**Re: Nusenda Credit Union
6401 Uptown Blvd NE
Traffic Circulation Layout
Architect's Stamp 10-31-25 (H18-D012)**

The TCL submittal received 11-10-2025 is approved for Building Permit by Transportation. A copy of the stamped and signed plan will be needed for each of the building permit plans. Please keep the original to be used for certification of the site for final C.O. for Transportation.

SITE PLAN

SITE DETAILS

date: 10-31-25
 sheet: A001

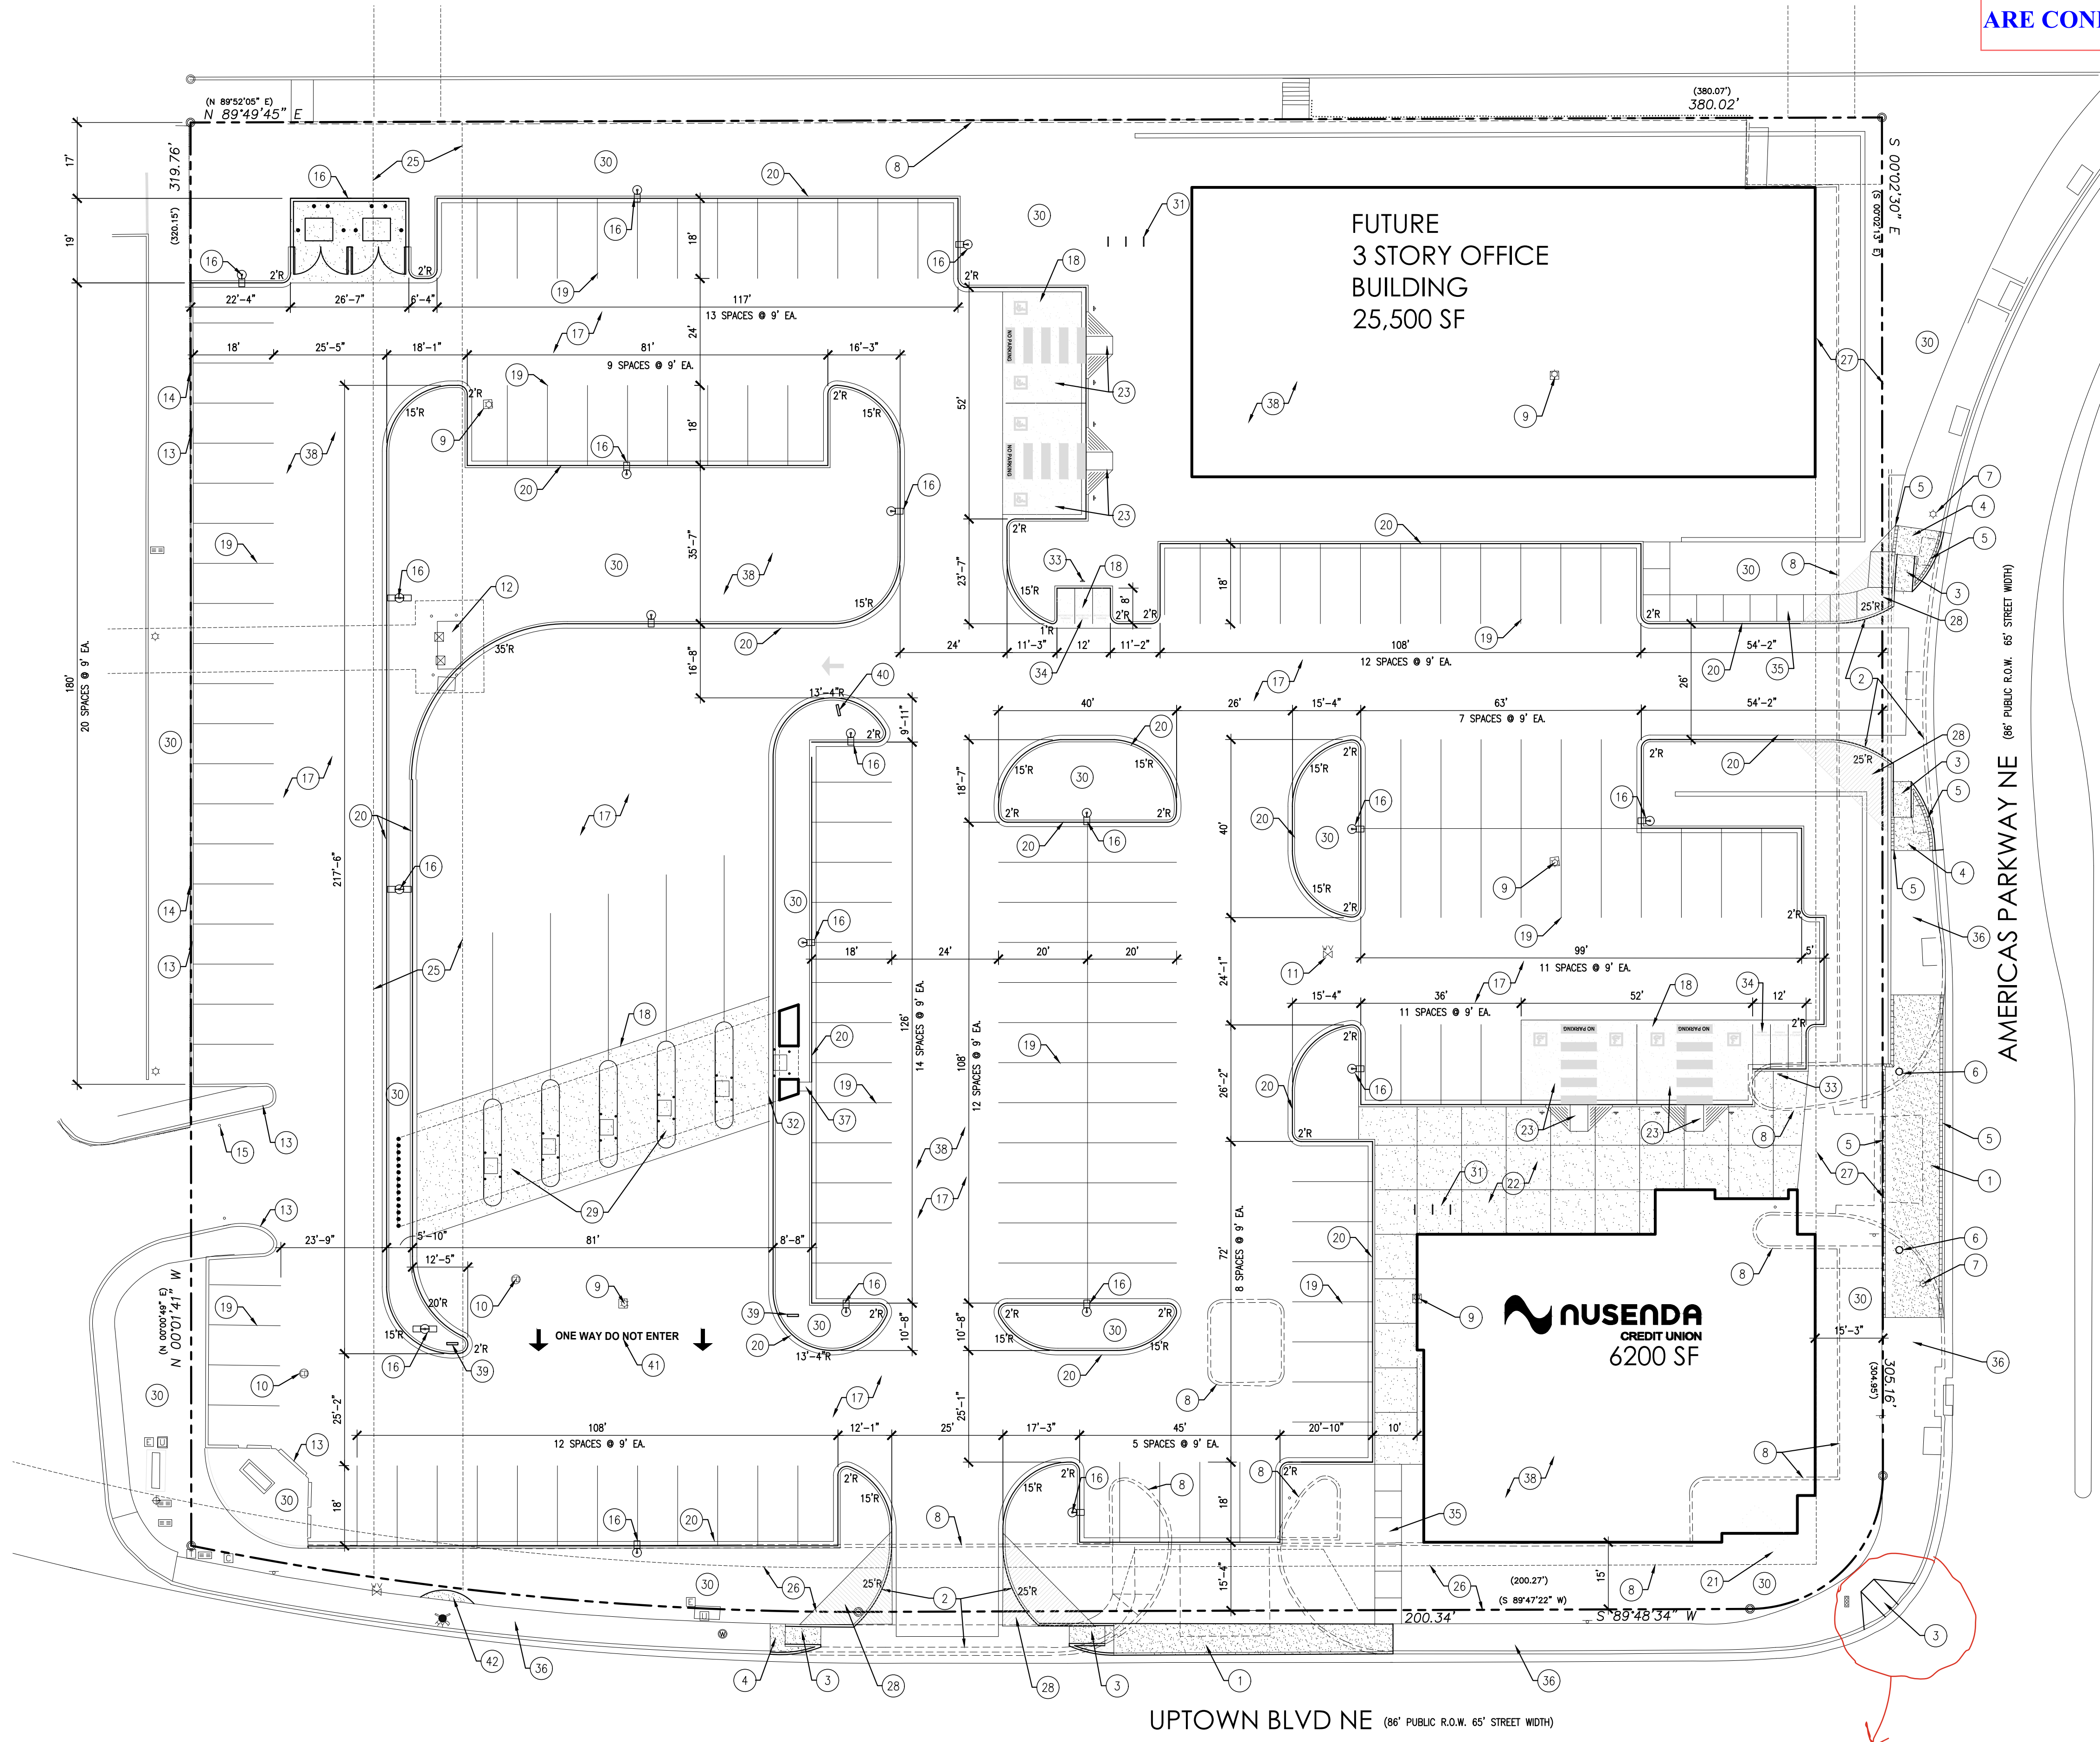
KEYNOTE 3: ADA RAMP MUST BE BUILT PER CITY STD DWG 2446 DETAIL (PLACEMENT ON PERPENDICULAR CURB RAMPS WITH FLARED SIDE SLOPES).
